ADDENDUM DATE: December 21, 2023

ADDENDUM NO. 5

Cobblestone Manor
1050 Lamplighter Drive
Grove City, Ohio 43123

Addendum No. 5 to the Drawings and Project Manual, dated June 8, 2023, Cobblestone Manor as prepared by Moody Nolan, Inc., 300 Spruce St. Suite 300, Columbus, OH 43215.

AREA PLANS - GROSS

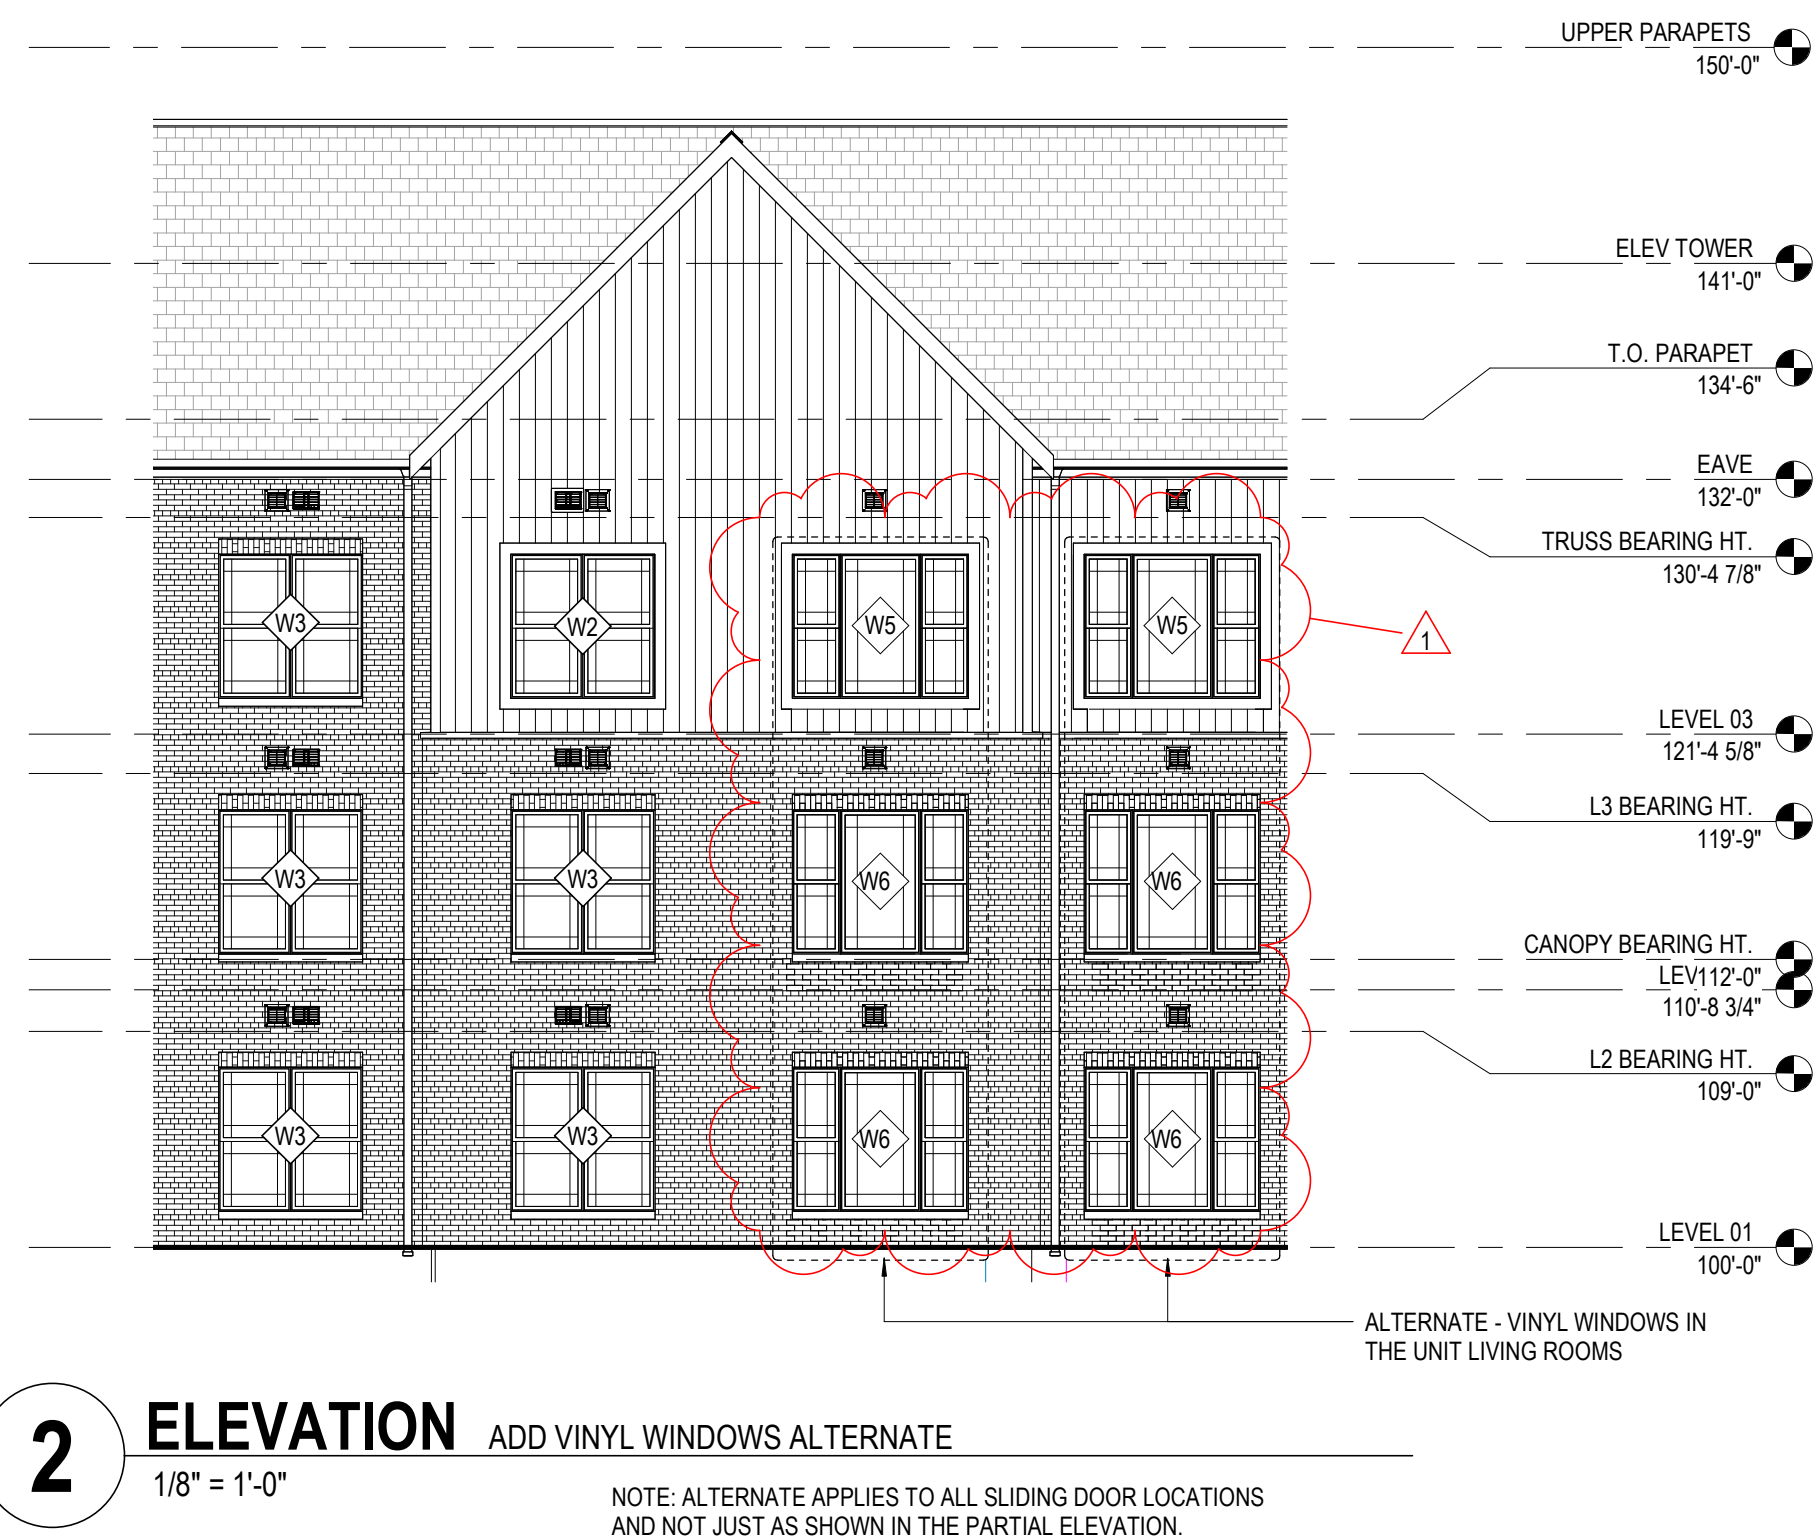
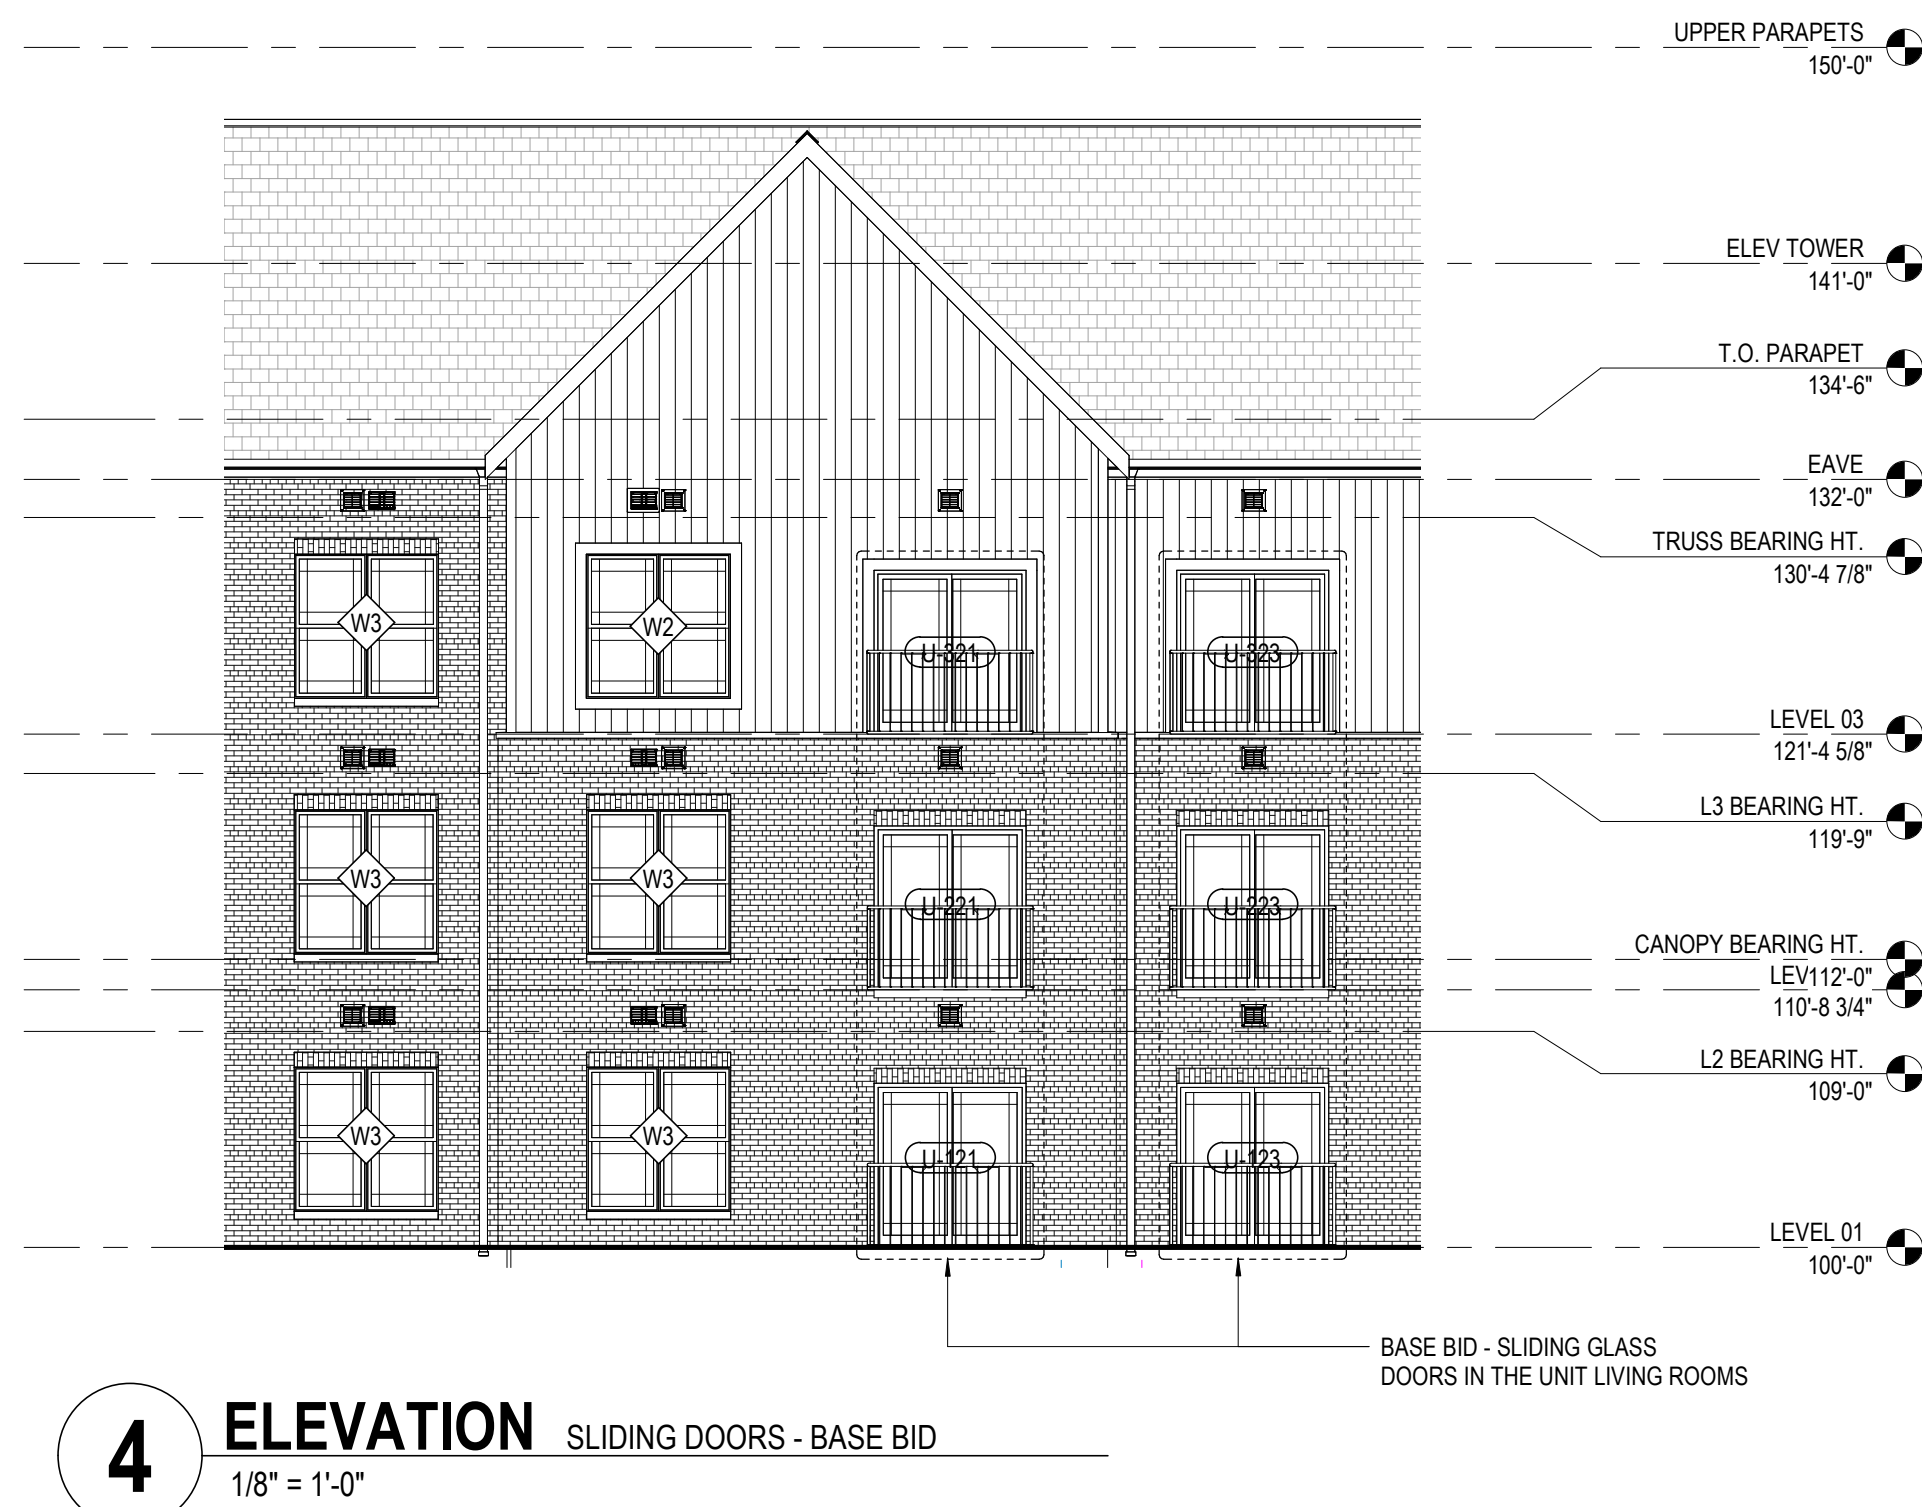
13. *Please confirm that there is no unit type C. A505 enlarged plan shows a 2c and A103 3rd floor too but in the unit matrix there is not a unit type 2c. please confirm if that is 2b-s unit.*

- a. G201 AREA PLANS – GROSS
 1. **REVISE** Plan 3 and the Unit Matrix Schedule to include unit name "UNIT 2c".
- b. G400 DEDUCT ALTERNATES
 1. **DELETE** Plan 1 & 3.
 2. **DELET** Alternates Note B.
 3. **REVISE** Elevation 2 window tags.
- c. C2.3 STORM SEWER DETAILS
 1. **REVISE** Detail A & B to reference control panel location.
 2. **REVISE** Detail A submersible pump requirements.
- d. C3.1 UTILITY PLAN
 1. **ADD** Coded note 5 to clarify control panel location.
- e. A101 LEVEL 01 - FLOOR PLAN - OVERALL
 1. **REVISE** layout of Amenity Kitchen.
- f. A101A LEVEL 01 - FLOOR PLAN - AREA 'A'
 1. **REVISE** layout of Amenity Kitchen.
- g. A450 ROOF DETAILS
 1. **REVISE** Detail 1 to clarify primary scupper size.
 2. **REVISE** Detail 2 to clarify overflow scupper size & location.
- h. A506 ENLARGED PLANS - LEVEL 01 COMMON AREAS
 1. **REVISE** layout of Amenity Kitchen.

Response: Unit 2c is located on Level 03 (Unit #U-311). See unit naming key below for clarification. The Area Plans have been revised to reflect this update. See revised Sheet G201 released as part of this Addendum.

06/08/2023	
DRAWN BY: KGW	CHECKED BY: EJW
#22172.01	
C2.3	
PERMIT & BID SET

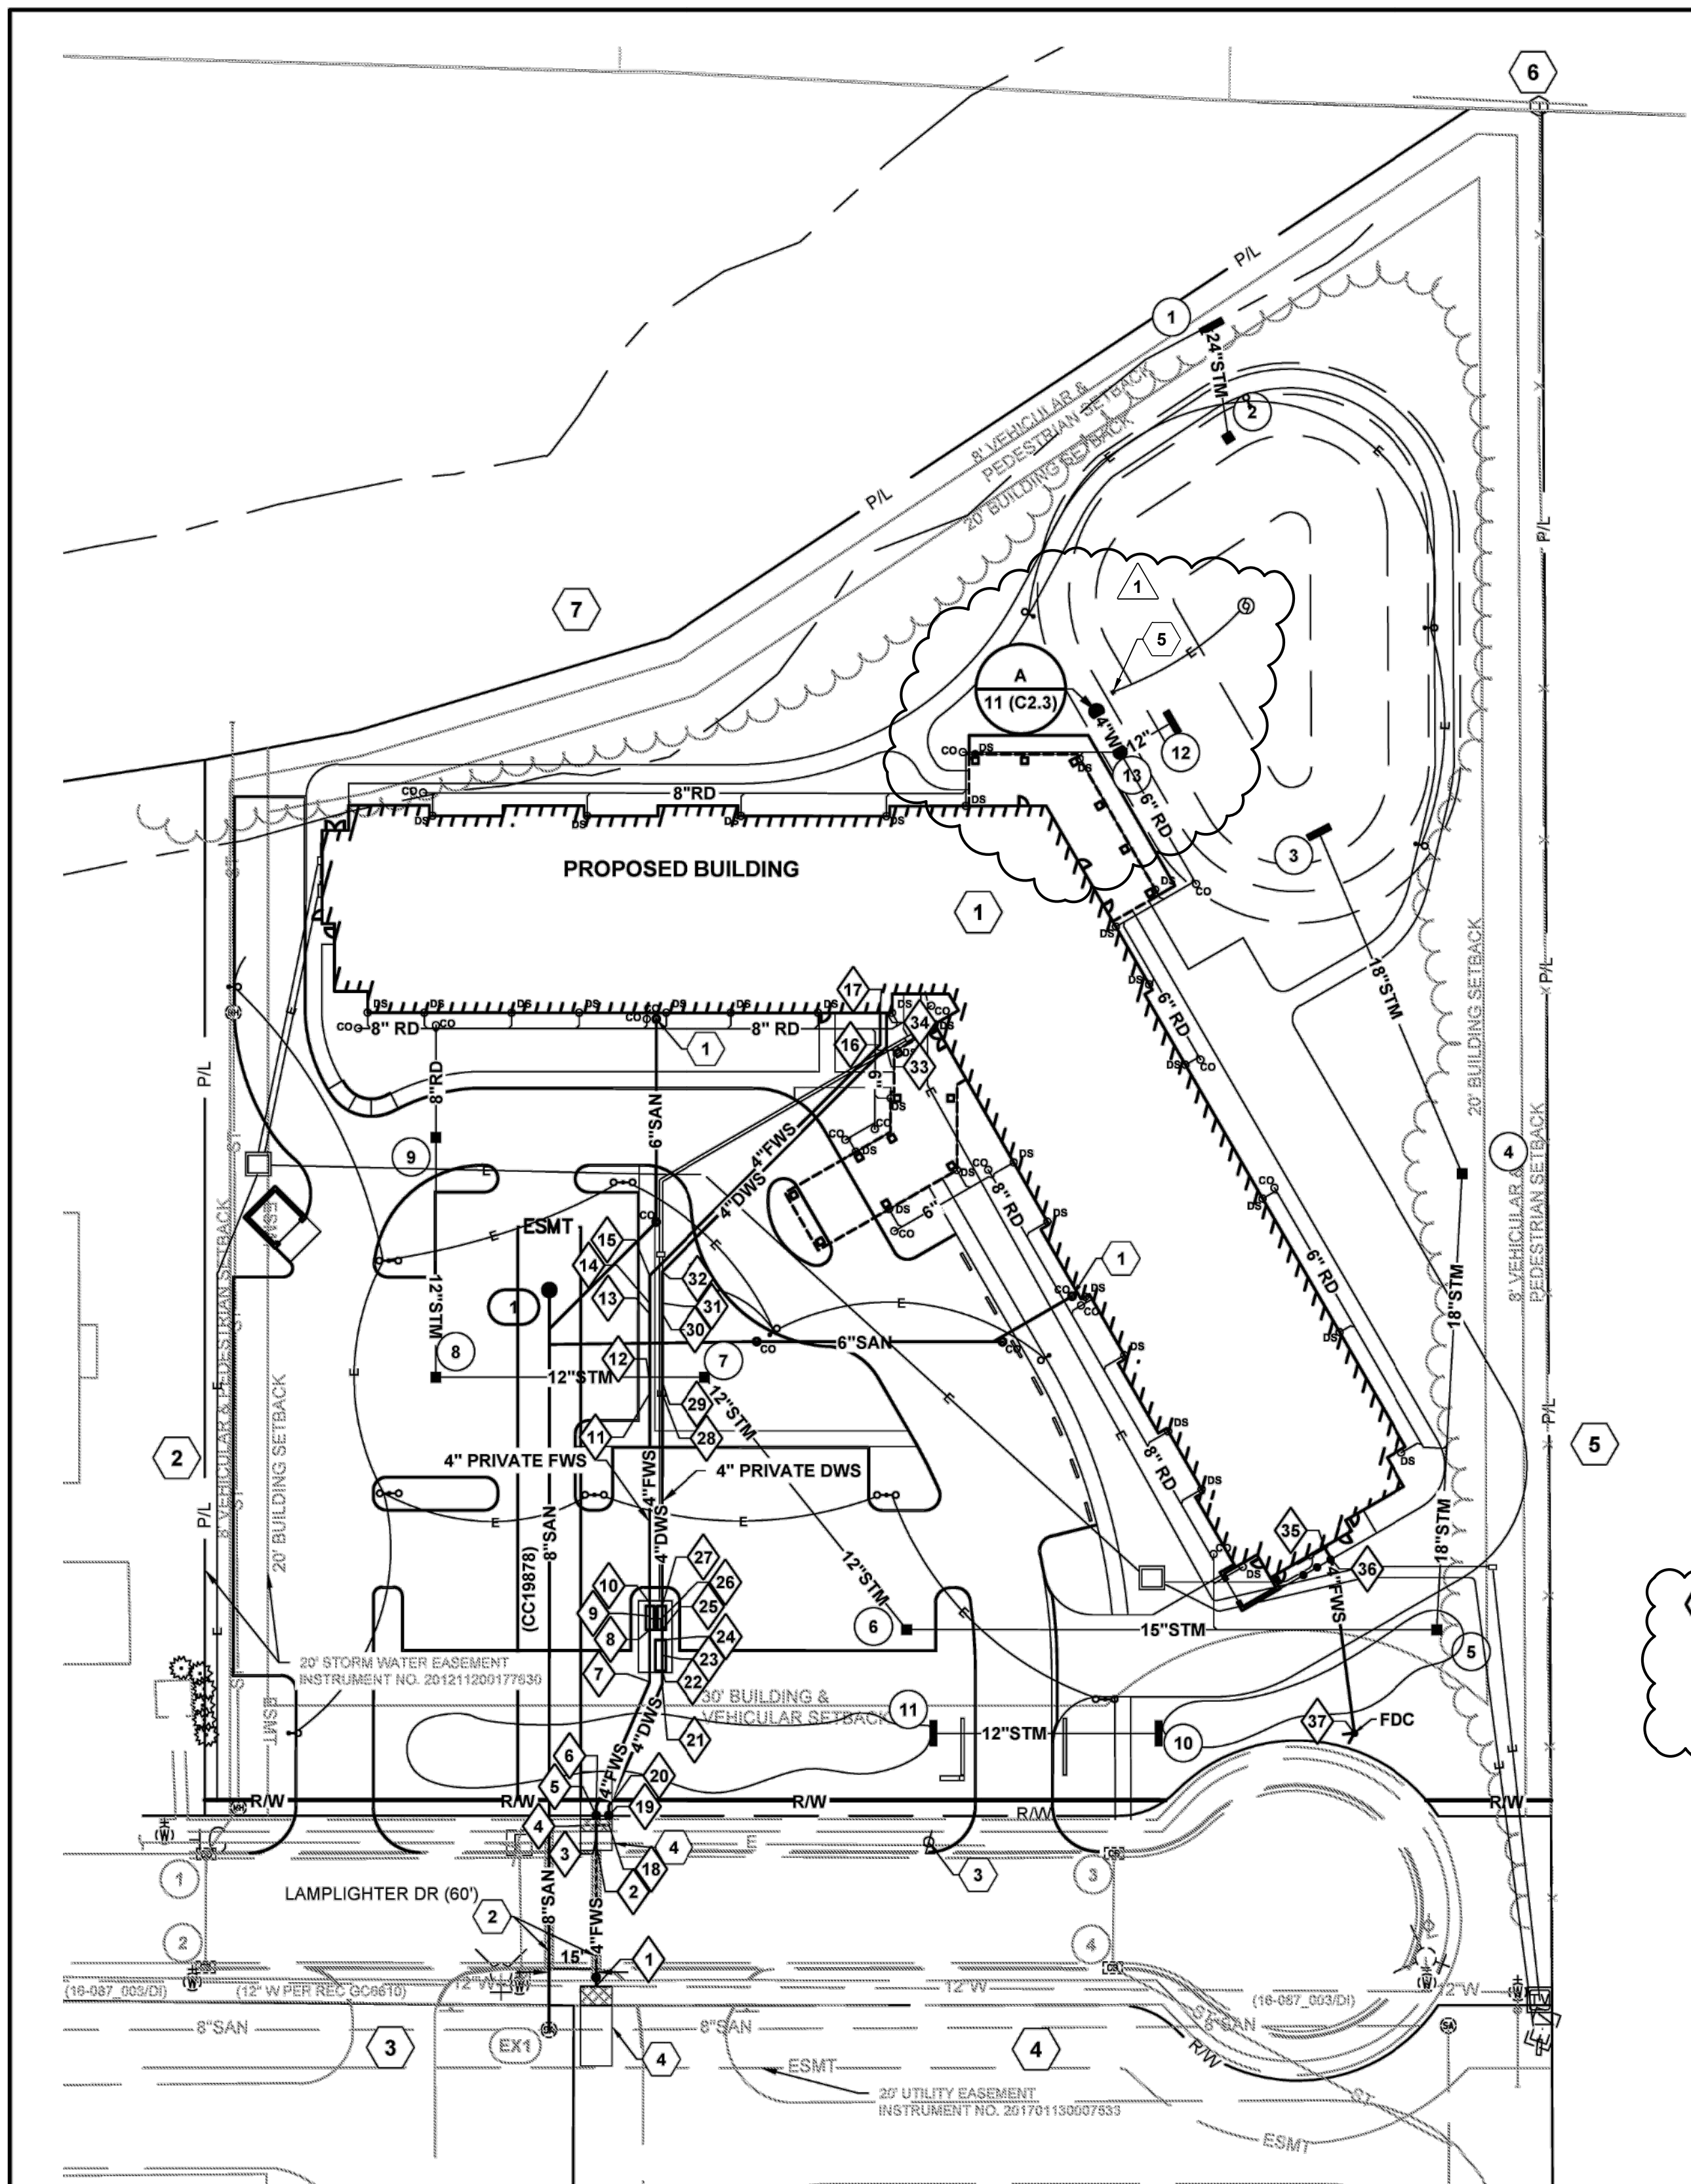
15. *Per note 7 in Detail B/C2.3 please provide the location for the recharge well control panel.*

Response: Plans have been updated to locate the control panel. Refer to sheets C2.3 and C3.1.

5 ELEVATION W5 - EXT. WINDOW TYPE
1/4" = 1'-0" REF: 1 / A1.3

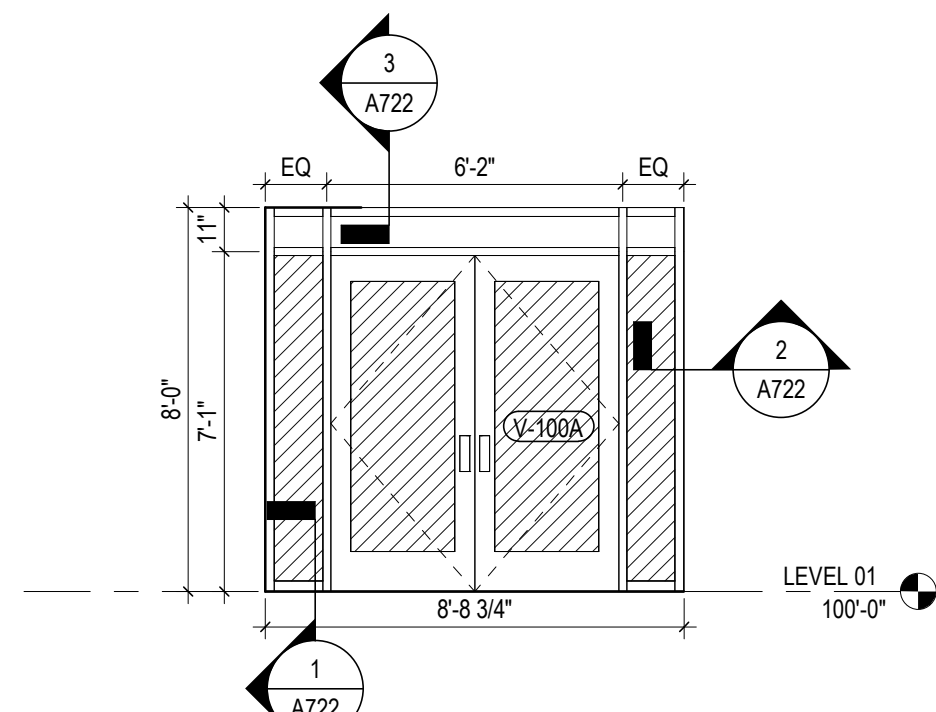
- i. A702 STOREFRONT & WINDOW ELEVATIONS
 - 1. **REVISE** Elevation 5 to clarify window type W5 is an alternate.
 - 2. **ADD** Elevation 21 for Window W28.

Response: Window Type W28 has been added to the window elevations sheet and the Window Type W5 elevation has been revised for clarity. See revised Sheet A702 released as part of this Addendum.
